# Part 5 Application **ACCESS REPORT**

**Reference Number:** 23183

Homes NSW – 46 Chester Ave,  
Maroubra, NSW

## Executive Summary and Design Compliance Statement

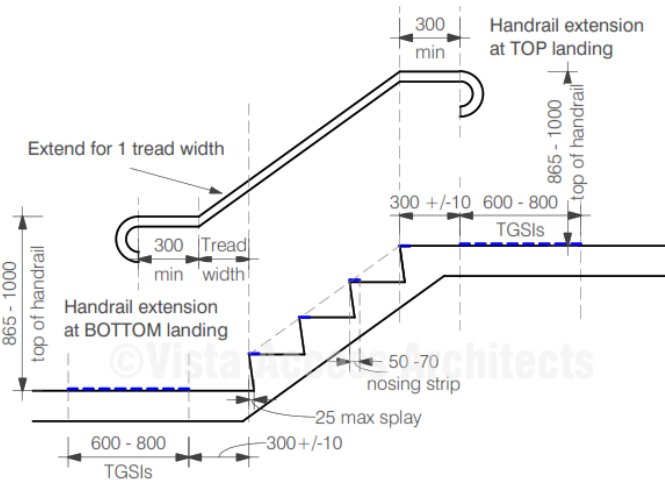
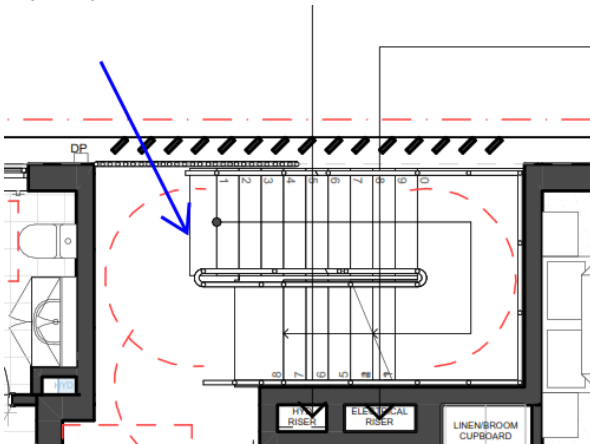
Ensure that the first riser going up on all mid landings are offset or provide for a minimum 300mm handrail extension

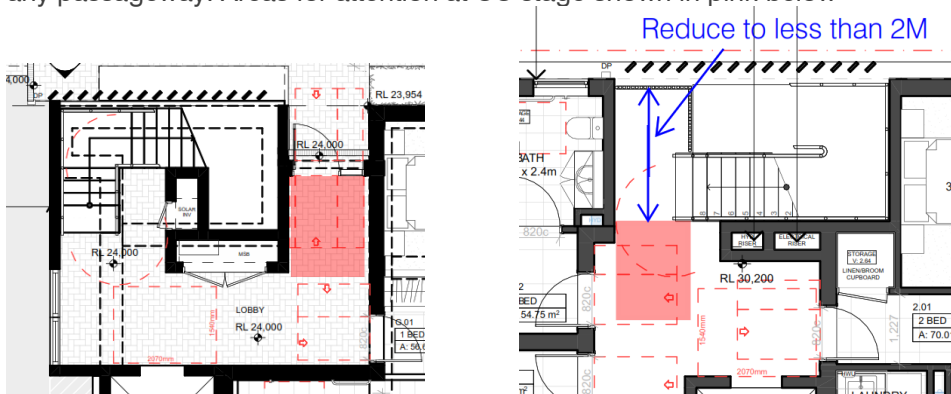
Ensure that the end of passageway turning spaces are provided at the end or within 2M of the end of any passageway. Areas for attention at CC stage shown in pink below

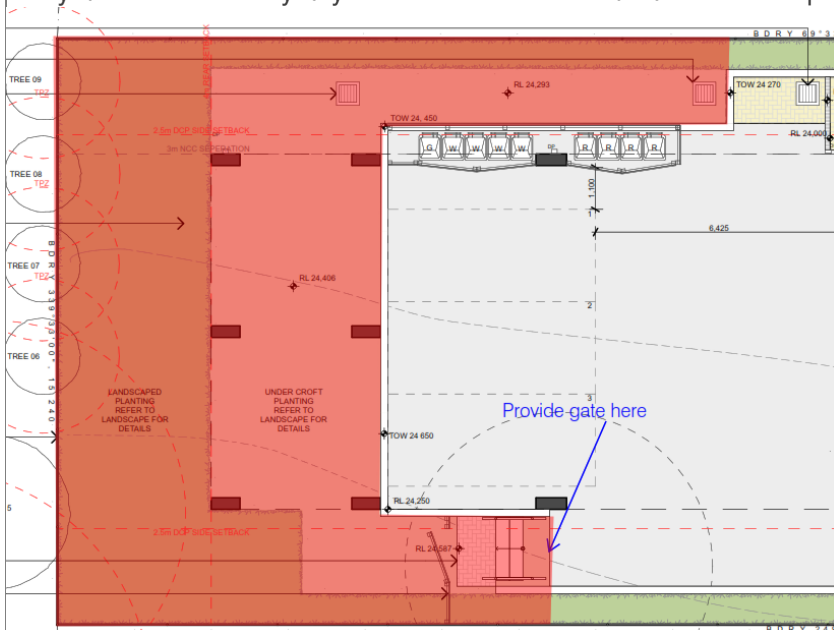
We have been advised that a large area (approx. 140 sq.m) is exclusively provided for maintenance staff only and not for use by any of the residents. This area is shown in pink below. If no access is provided

for the residents whatsoever then it is our opinion that a gate that is lockable is to be provided before the start of the stairway blocking off access to the stairway. The stairway in which case will be exempt from all access related requirements.

Note that if access is to be provided to residents then this will need to be redesigned with a step free ramp access. This is to be verified at CC stage of works.
